AGENDA

President and Board of Trustees
Village of Arlington Heights

March 19, 2018

- A. Sigwalt Apartments/CA Ventures - 45 S. Chestnut Ave. -
PC#17-016
PUD, Preliminary& Final Plat of Subdivision, Rezoning, Variations

C6.2

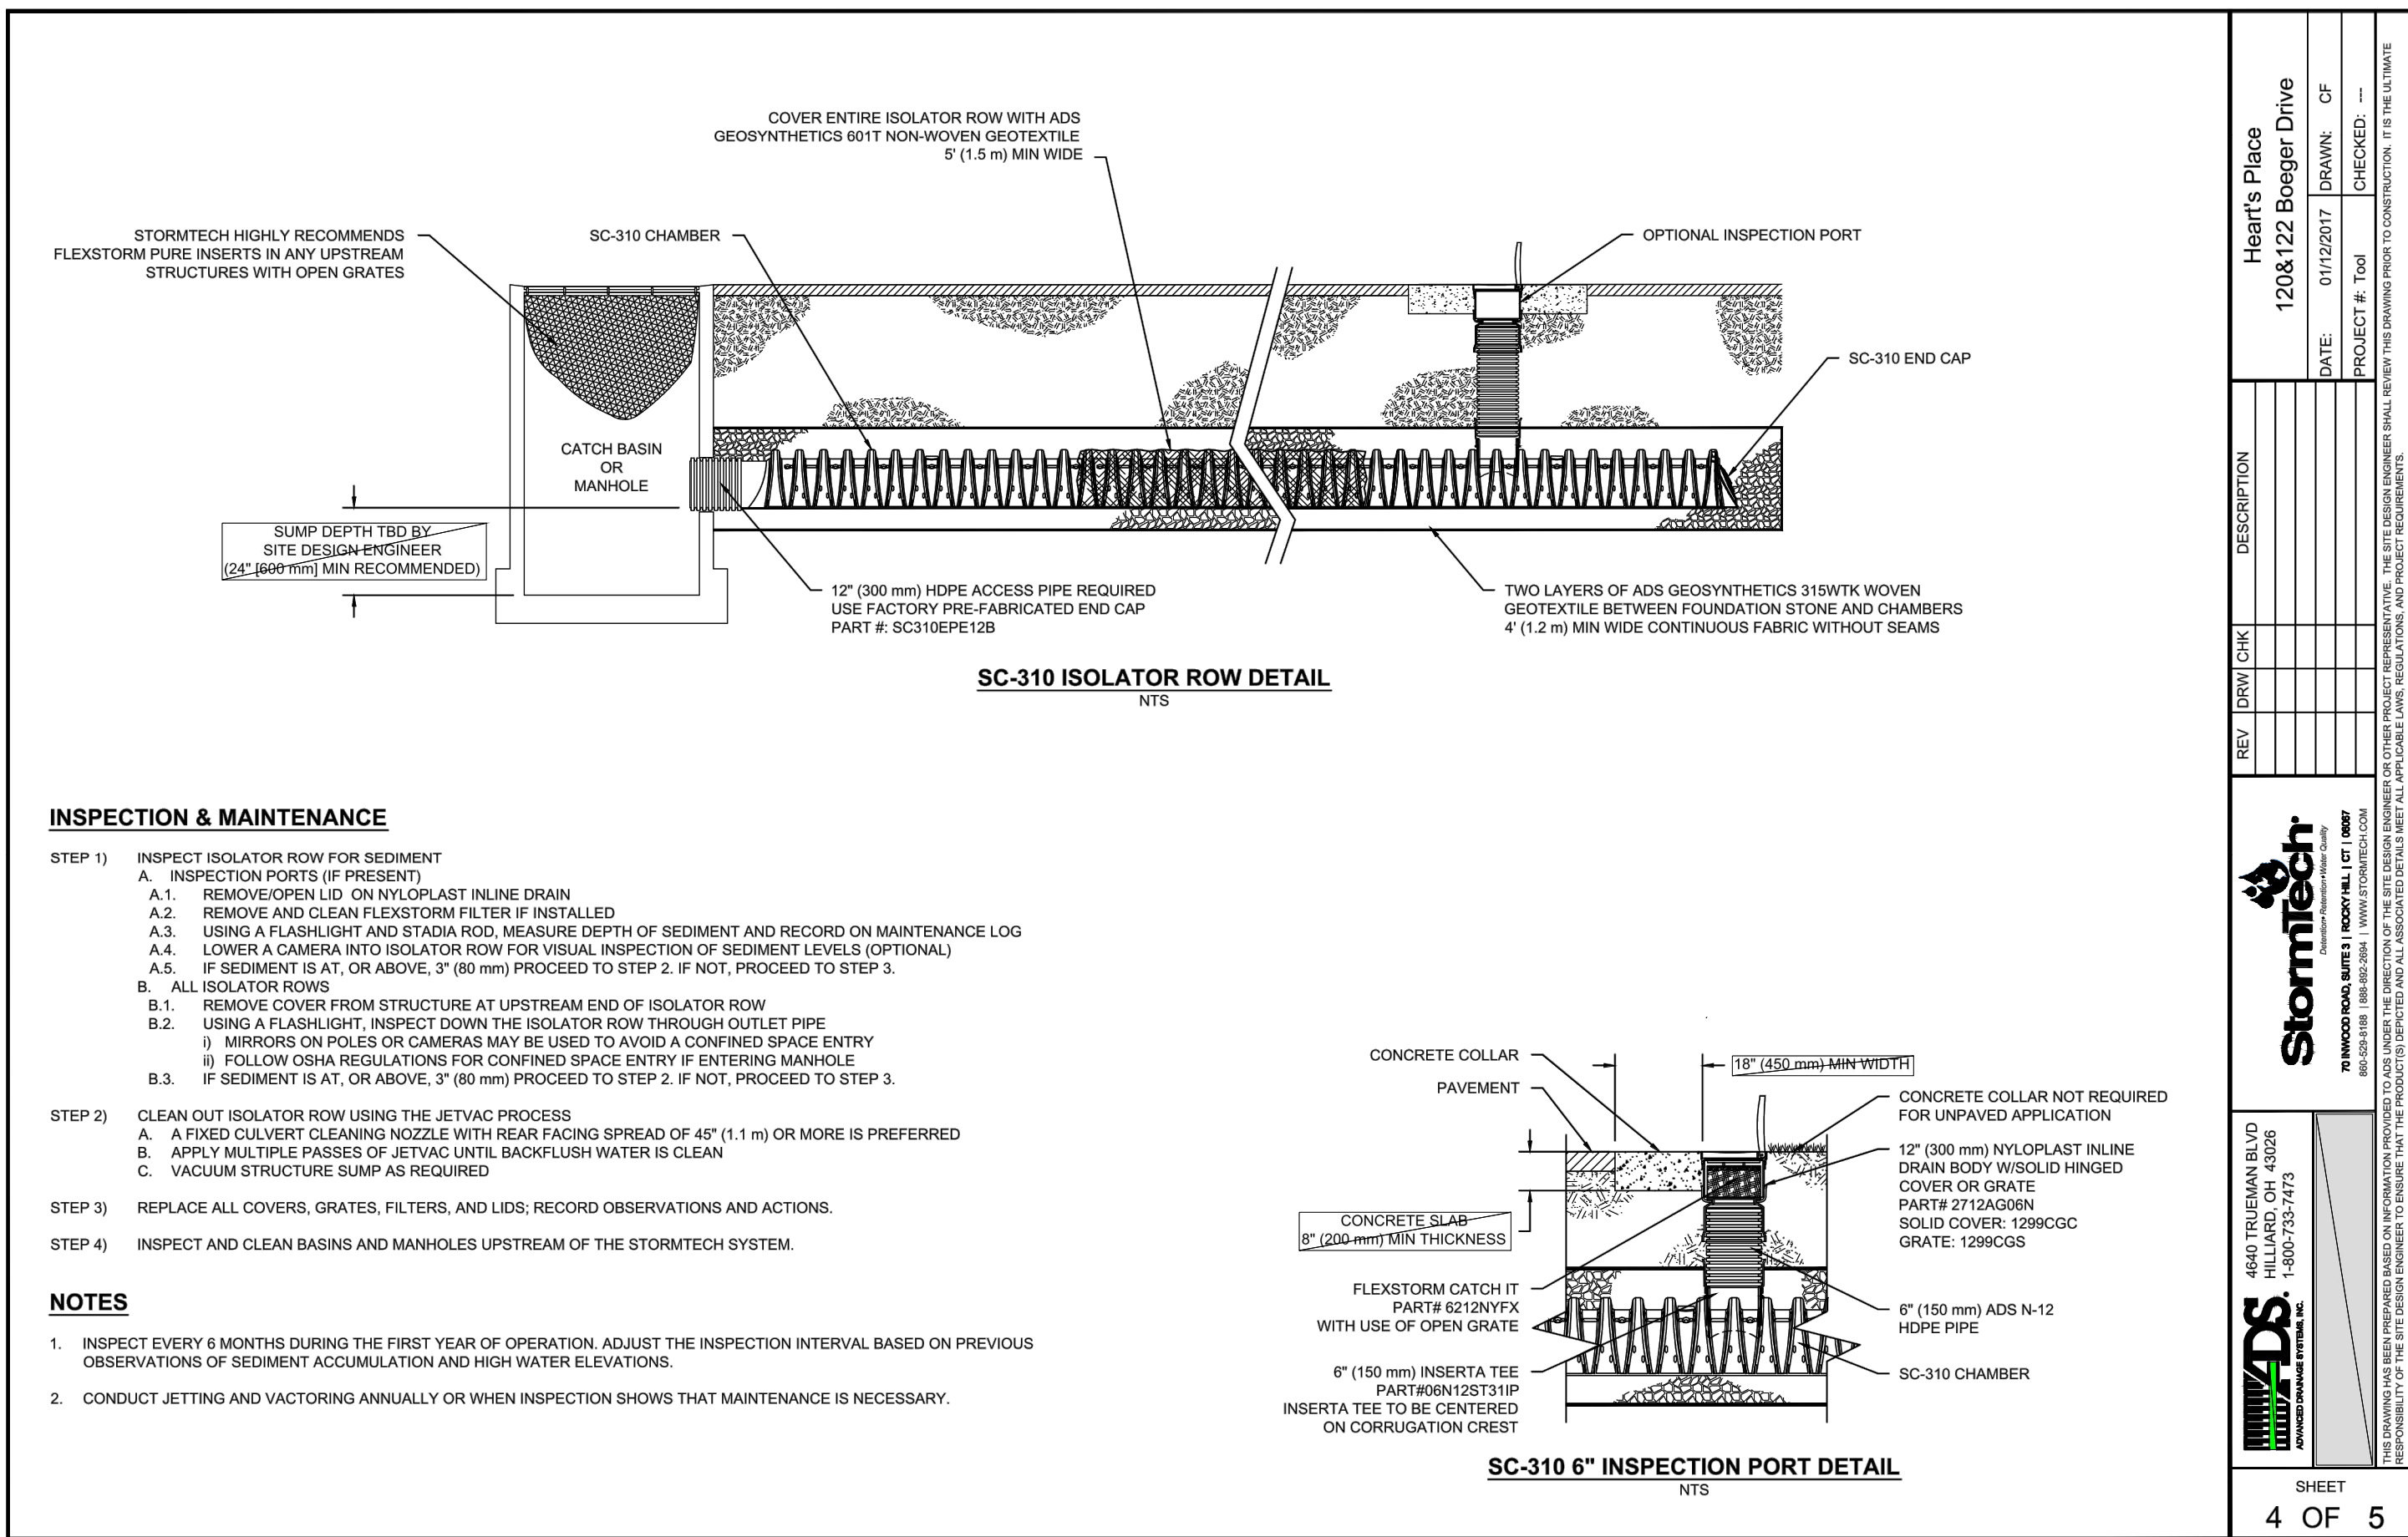
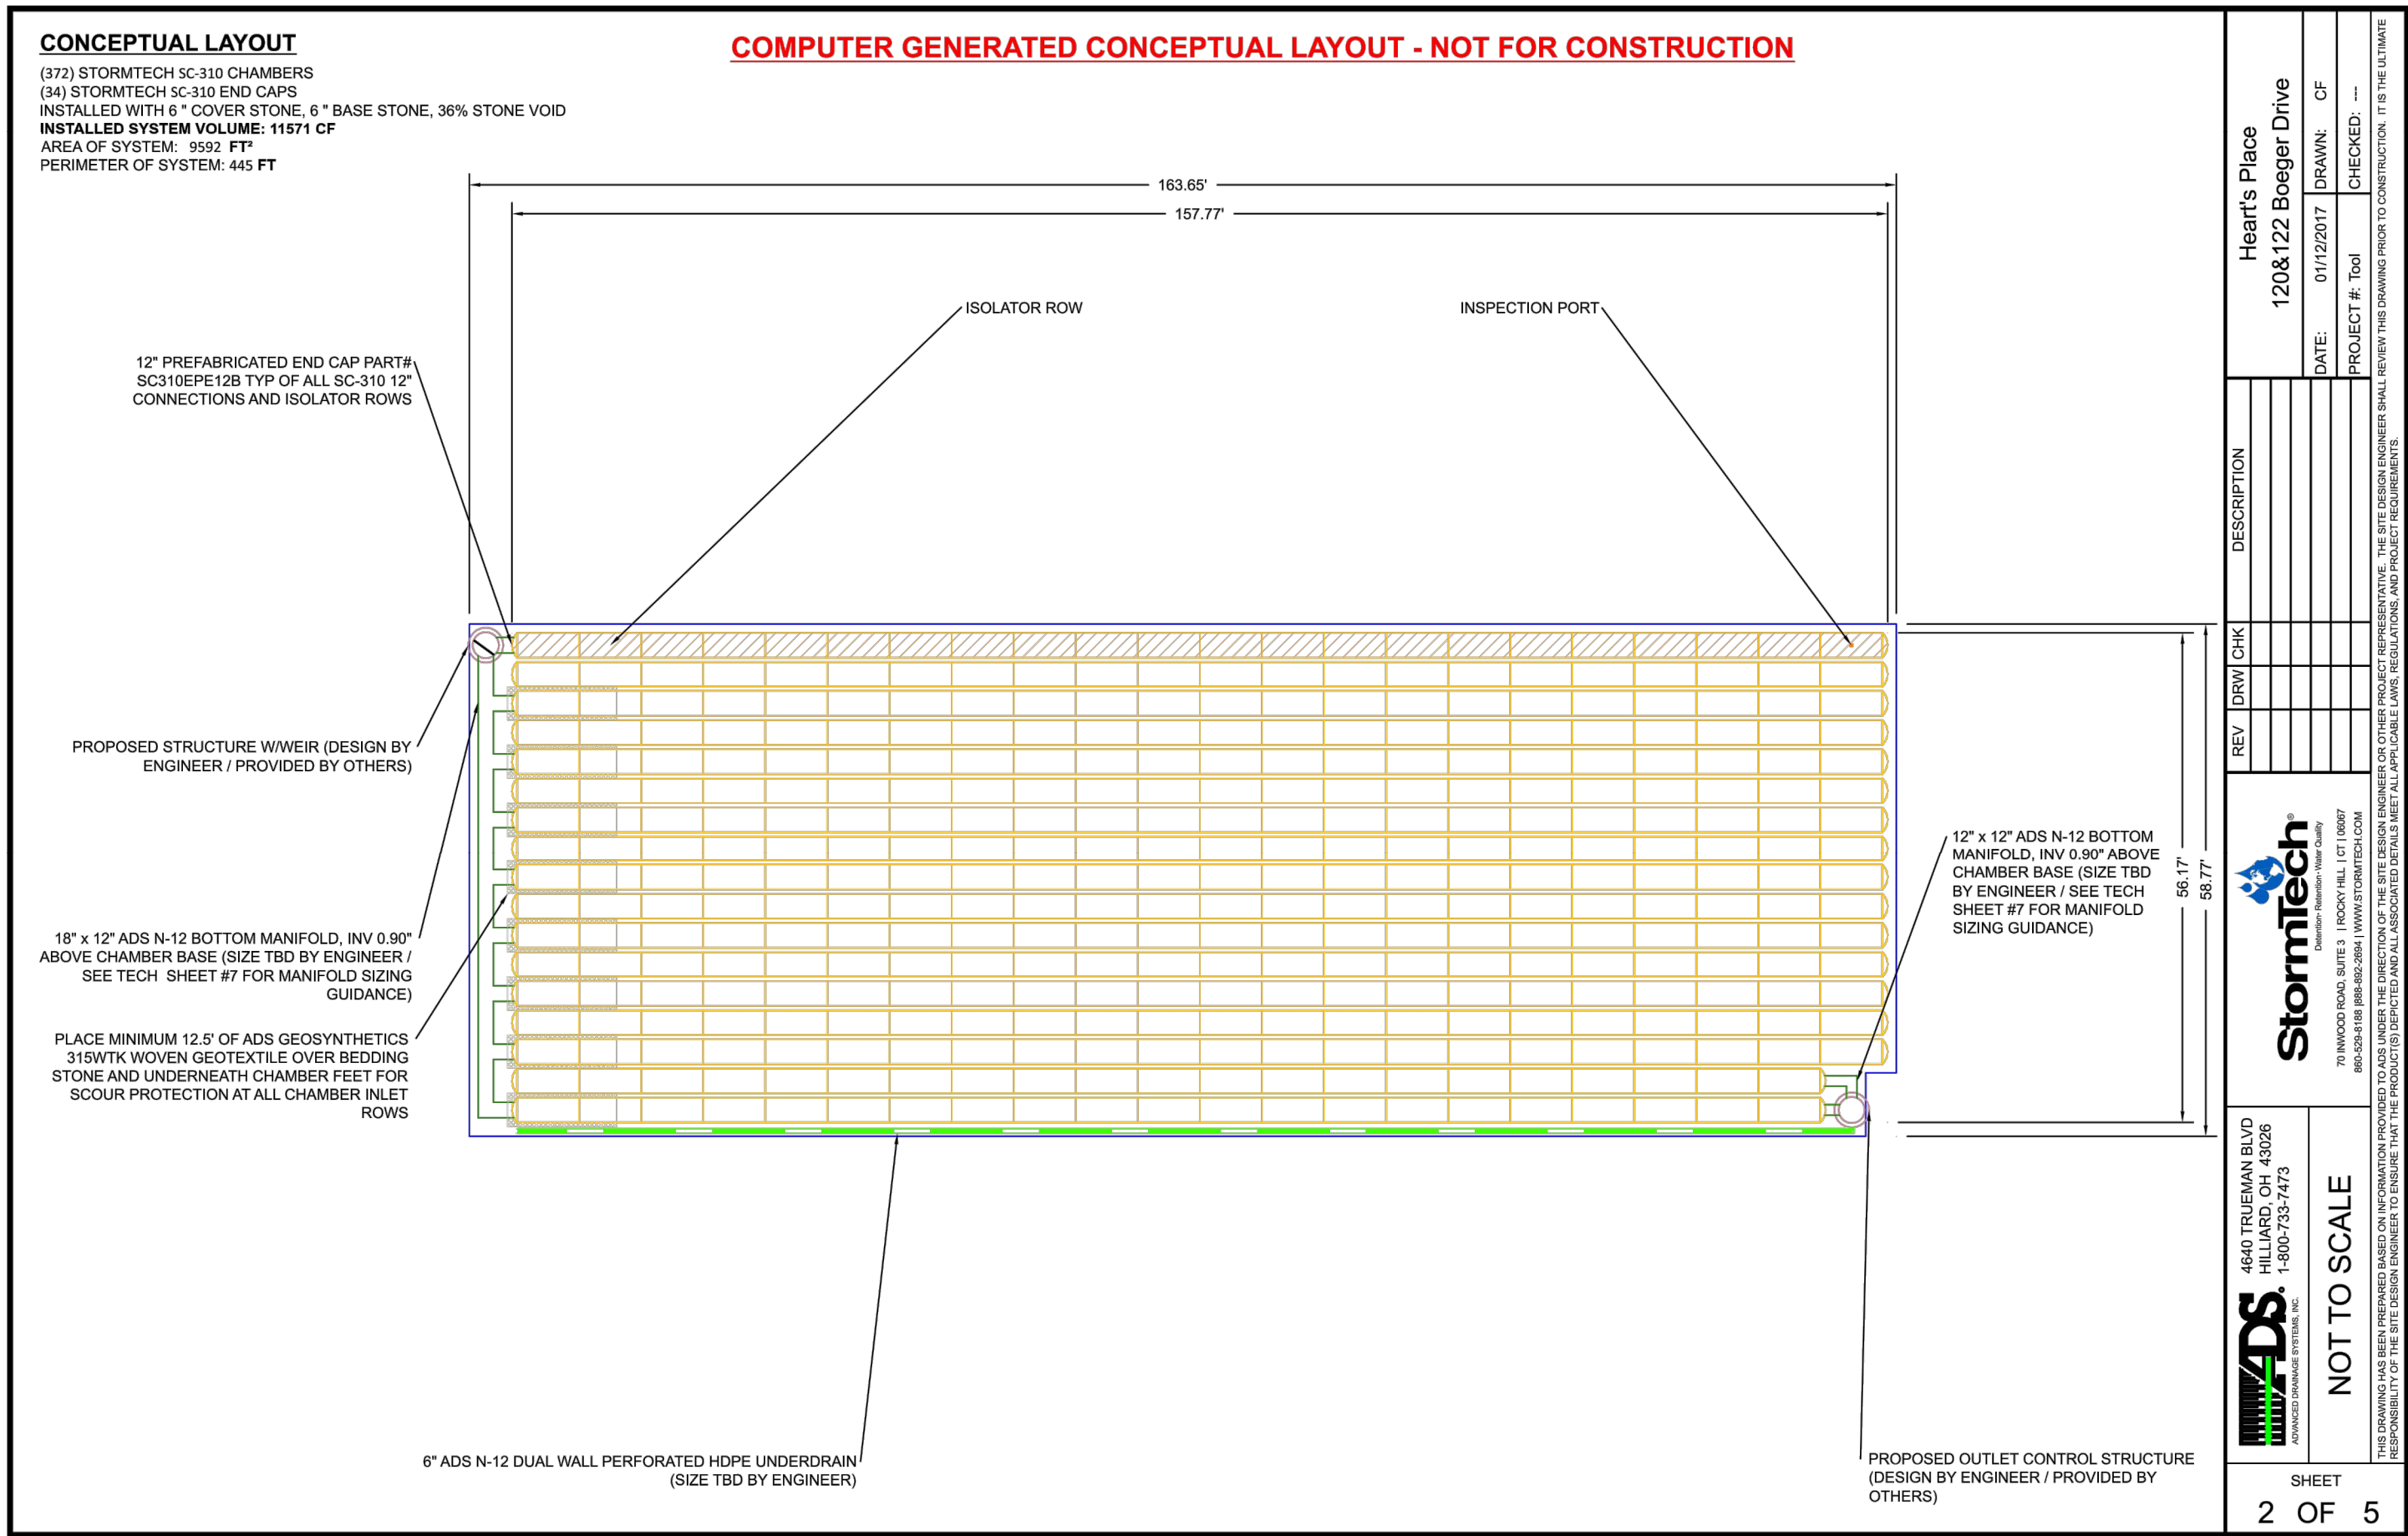
17. Provide cut sheets or plan details from the manufacturer for the proposed StormTech system, including design loading criteria and proposed volume.
18. Sheet CX-1.1: Village Code requires fire hydrants at a maximum spacing of 330'. Add a fire hydrant somewhere between Station 1+50 and Station 2+75 on the new water main extension.

RESPONSE: Per coordination with the Engineering Departments, the details were previously provided and accepted on the Building Permit Submittal plans. The details can be seen on C6.2 & C6.3

CX1.1

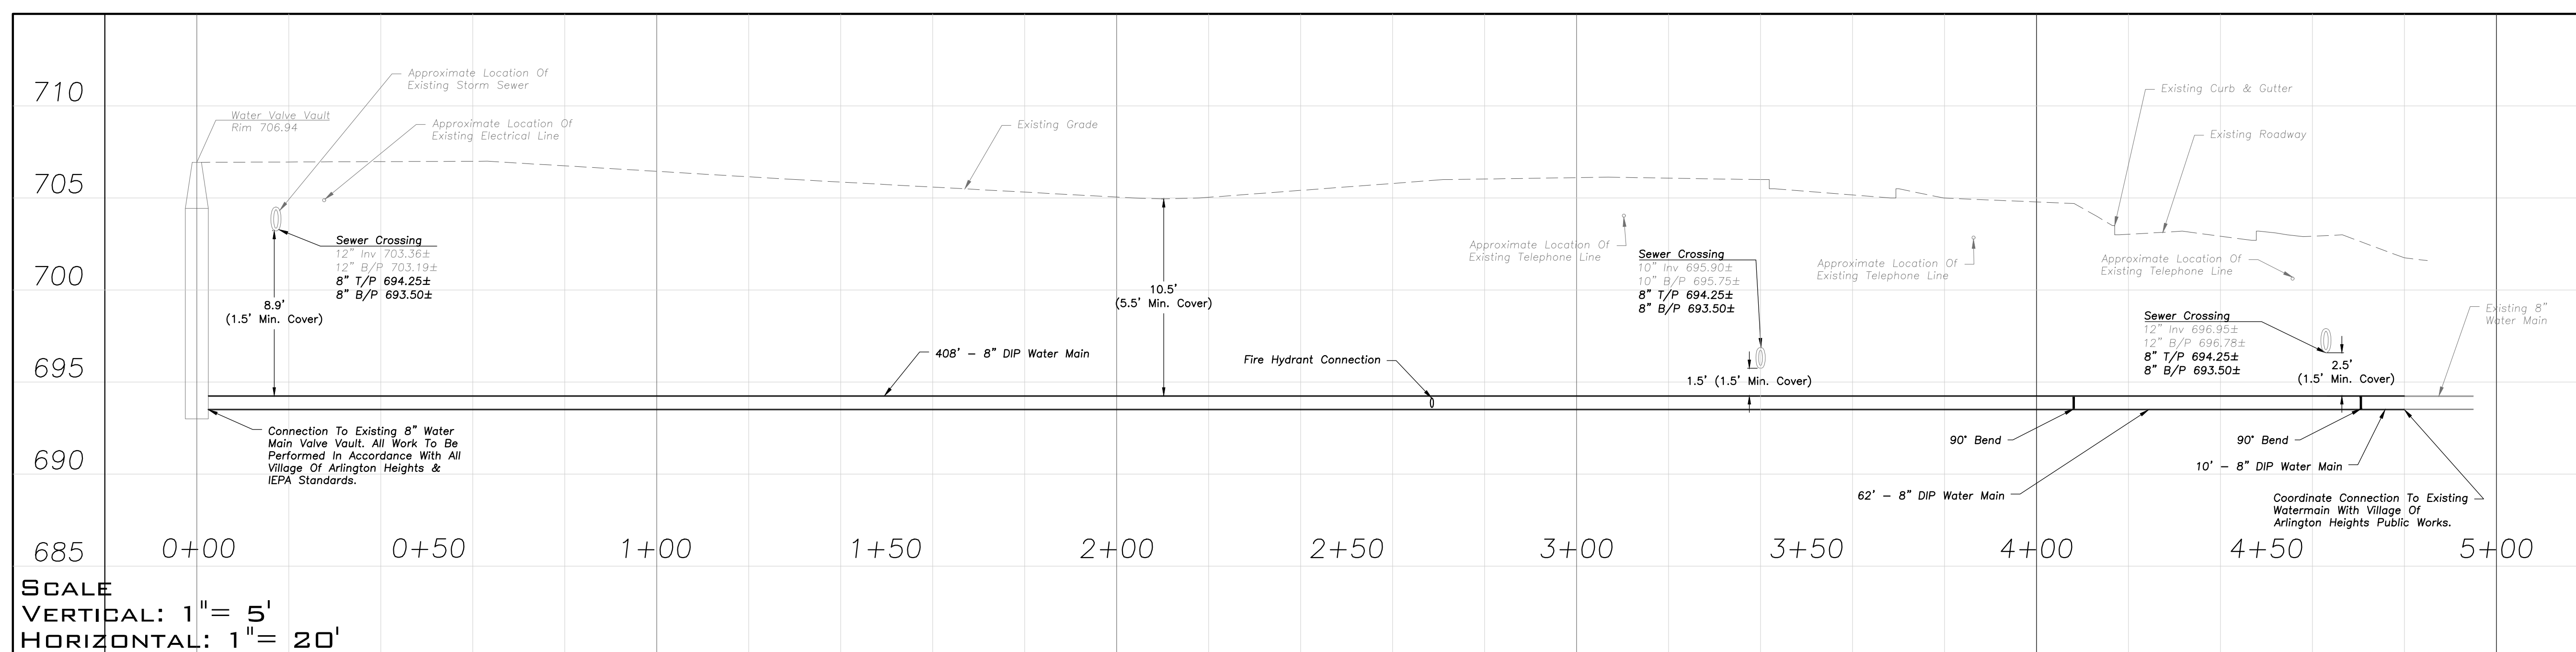
19. Sheet CX-1.1: Verify with the Public Works Department as to how they want the water main connection at the east end of the extension to be designed: whether to use a pressure connection and leave the dead end or eliminate the dead end and install a 90-degree elbow.
